STAFF REPORT

CONCERNING APPLICATION FOR A CERTIFICATE OF APPROPRIATENESS

Application Number: 2018-0911A

Property Location: 510 S Carroll

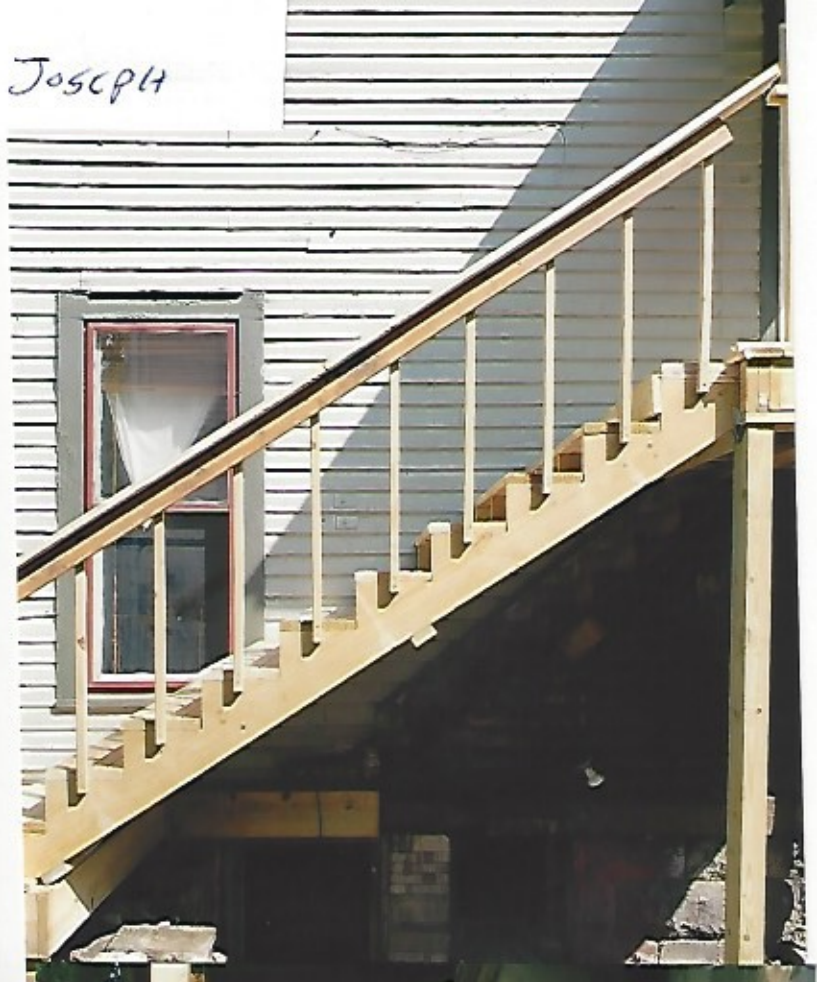
1. Outdoor Side Stair replacement. These stairs were failing and needed to be replaced. They were never installed properly and were attached to a stone and brick wall which was about to fail. We replaced the steps without approval, therefore we have pictures of the actual replacement step. I have included pictures of the new steps and the old steps from the street.

2. Replacement of fallen down fence. We have installed the fence in the back of the property. Included is a picture of the new fence.
3. Windows. We are requesting replacement of 7 windows on the west side of the house. These windows no longer have the weight system working. Since they are large windows they do not stay up and the wood is deteriorating. The current windows are wood and on the exterior there are aluminum storm windows. The storm windows are painted red. We are requesting the removal of both the wood windows and the storm windows. The new windows would be white and would be custom sized to fit exactly in the existing window frame. The windows we are planning to purchase are Jeld-Wen Best Series model JW1438. We would purchase from Menards. There are other windows in the house which were replaced with white vinyl windows. I have pictures of the windows we are requesting replacement and we purchased 1 custom window so you can see it has a similar sized frame as the original windows. Long term we would like to find a paint scheme which would incorporate white windows. We are open to any suggestions.

4. The siding on the second floor in the back is in poor shape some is green and other is red all do not match the house. We would plan to put in vinyl siding to come close to matching the house color. See pictures.

Regarding the external stairwell: in the period of time from the establishment of the district in 1998 until today, three out of the five Certificates of Appropriateness on file for this property have been received for projects related to the external staircases. As such, precedent has been established and staff recommends approval.

Regarding the retroactive reconstruction of the fence using the existing fence posts, staff recommends approval.

Regarding the removal and replacement of the windows with Jeld-Wen vinyl windows, staff recommends approval based upon Inspector Szaday’s opinion of the existing window condition.

Regarding the replacement of the exterior mastic siding with vinyl siding on the rear upper story of the structure, staff recommends approval.
